**RE: Ecological review of Species Impact Statement for DA2017/0385**

Pursuant to your request, I have completed a review of the Species Impact Statement (SIS) provided by the Applicant (prepared by Narla Environmental, dated 18 December 2017) to accompany DA 2017/0385 for a private hospital at Lot 2 DP 1145029, 4A Larool Road Terrey Hills.

**FIGURE 1**

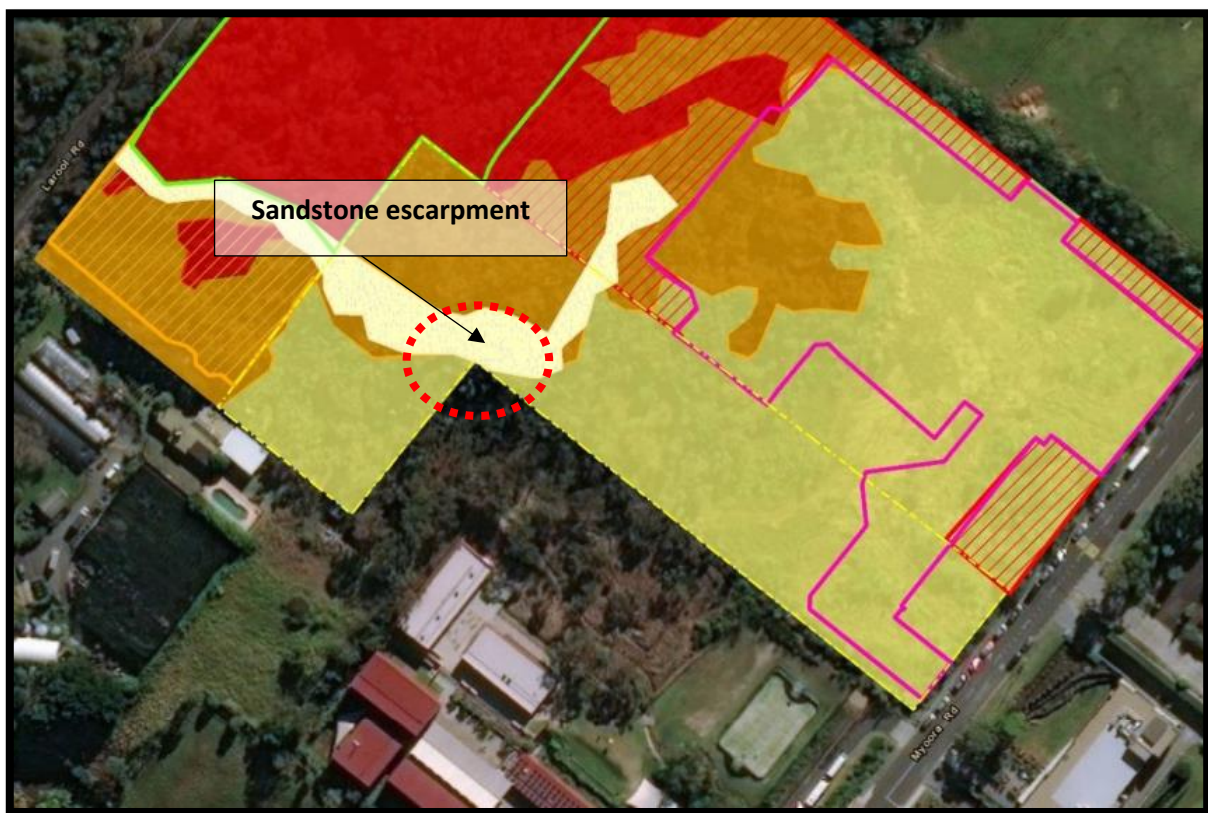
The most egregious of the matters not addressed is the continued disregard of the areas required to be cleared for the hospital development that happen to occur within the adjacent easement. In this way, the SIS persists in under-reporting the amount of clearing required for the subject development.

In addition to the clearing for the Asset Protection Zone (APZ) for the school in the easement, there is direct impact across approximately 0.22 hectares of bushland for the hospital development. This includes clearing for the APZ, as well as for the construction of the access for a fire truck. This additional area includes many important ecological features, the impacts of which have not been acknowledged and therefore not assessed. The impacts include the loss of at least 0.1 hectares is DF EEC, habitat for EPP, habitat for RG, and habitat for microbats. There is also no acknowledgement or discussion regarding how the fire access track is to be constructed, given that it is mooted to cross over the sandstone escarpment (see Figure 1 below).

Fire truck access
